Access Compliance Report

Public Rights-of-Way

(Curb Ramps)

Intersection ID: 14461	Main Street: E_WORTHINGTON_AV	Cross Street: LYNDHURST_AV	Location: S
ADA ID: 0A85A8339654	Ramp Type: Perp	Initial Pass/Fail: Fail	Overall Compliance: No
Severity Score: 12.5			
Codes/Mitigation Info/Possible Solution		Field Measurements/Component Compliance

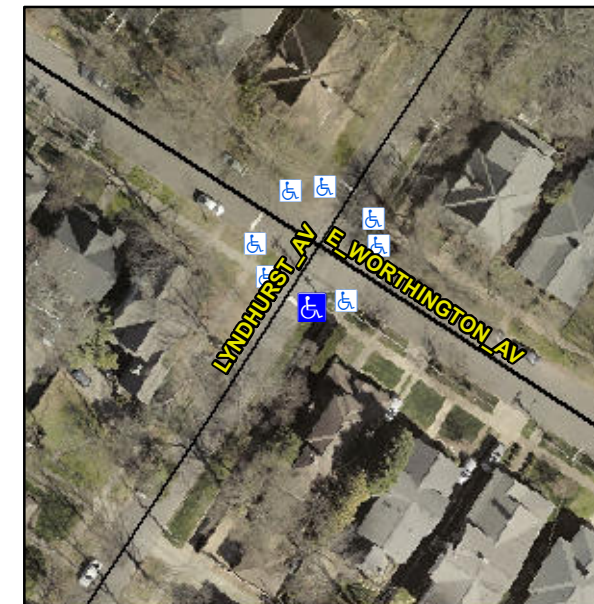
R304.5.3

Compliance	Description	Data	Compliance	Description	Data
N/A	Ramp Length (in)	136.0	Yes	Ramp Slope (%)	5.4
Yes	Ramp Width (in)	60.0	No	Ramp XSlope (%)	5.2
N/A	Flare Type LT	N/A	N/A	Flare Type RT	N/A
N/A	Flare Slope LT (%)	N/A	N/A	Flare Slope RT (%)	N/A
N/A	Flare Traversable LT?	N/A	N/A	Flare Traversable RT?	N/A
N/A	Landing Length (in)	N/A	N/A	DWS Provided?	N/A
N/A	Landing Width (in)	N/A	N/A	DWS Contrast?	N/A
N/A	Landing Slope (%)	N/A	N/A	DWS Length (in)	N/A
N/A	Landing X Slope (%)	N/A	N/A	DWS Full Width?	N/A
N/A	Landing Curb? (Y/N)	N/A	N/A	DWS Offset (in)	N/A
N/A	Shared Landing?	N/A			
N/A	Gutter Ponding?	N/A	N/A	Gutter Slope (%)	N/A
N/A	Gutter Lip Ht (in)	N/A	N/A	Gutter X Slope (%)	N/A
N/A	Painted X Walk1?	No	N/A	Painted X Walk2?	N/A
	X Walk 1 Direction	To NW		X Walk 2 Direction	N/A
N/A	X Walk 1 Width (in)	N/A	N/A	X Walk 2 Width (in)	N/A
	X Walk 1 Slope (%)	4.1		X Walk 2 Slope (%)	N/A
	X Walk 1 X Slope (%)	3.9		X Walk 2 X Slope (%)	N/A

Remove & Replace Entire Ramp.
